Project	IEEE 802.16 Broadband Wireless Access Working Group http://ieee802.org/16 >		
Title	Fast Uplink Bandwidth Allocation for Intermittent Short Packets		
Date Submitted	2005-01-13		
Source(s)	Yerang Hur, Bong Ho Kim, Jungnam Yun, Jaehyeong Kim, Seyoung Kim Posdata Co. Ltd. Voice: 408-986-1140 Fax: 408-986-1145 [mailto: {yehur,bhkim,jnyun,jaekim,seyoungkim}@posdata-usa.com}		
Re:	Corrigendum to IEEE Std 802.16-2004		
Abstract	Intermittent short packets cause network delays if bandwidths are allocated with contention-based CDMA bandwidth requests mechanism for OFDMA. This contribution proposes a contention-based bandwidth request mechanism for fast uplink bandwidth allocation so that OFDMA system can deliver intermittent short packets fast.		
Purpose	Review and adoption of the proposed text change into Corrigendum to IEEE Std 802.16-2004		
Notice	This document has been prepared to assist IEEE 802.16. It is offered as a basis for discussion and is not binding on the contributing individual(s) or organization(s). The material in this document is subject to change in form and content after further study. The contributor(s) reserve(s) the right to add, amend or withdraw material cont

Figure 1: Contention-based OFDMA BW Allocation Mechanism

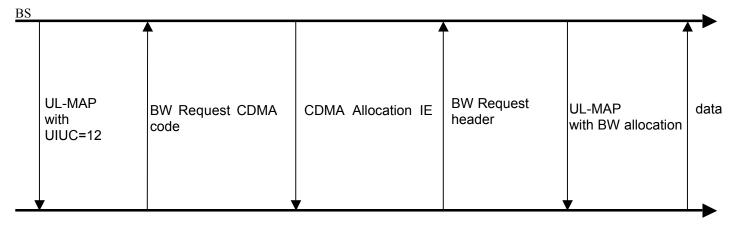
For delivering the intermittent short packets, an SS needs to request uplink bandwidth using contentionbased OFDMA BW requests described in 6.3.6.5. Figure 1 shows the contention-based OFDMA BW allocation mechanism described in 6.3.6.5. It requires minimum five message transfers between BS and SS: three from BS and two from SS until the SS starts to send data. This overhead can be reduced to three messages: two from BS and one from SS, if the SS informs a BS that data to be transmitted are short.

Figure 2: Contention-based OFDMA BW Allocation Mechanism with Fast BW Allocation IE

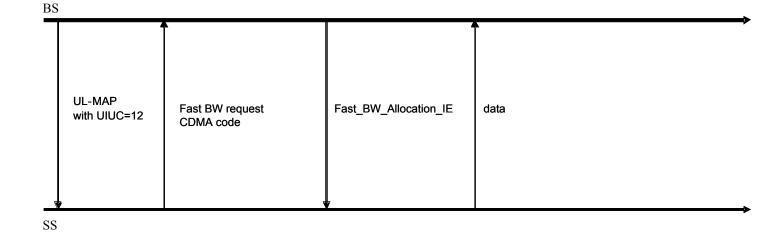
31 32 Figure 2 illustrates how the BS allocates bandwidth for short packets using the proposed method.

- 1. A SS sends a bandwidth request using the Fast BW Request CDMA code, if the amount of the packets is less than m bytes, where m is implementation specific.
- 2. If the Fast BW Request code is identified successfully, the BS sends Fast BW Allocation IE to the SS with duration allocated.
- 3. The SS transmits data over the bandwidth allocated.
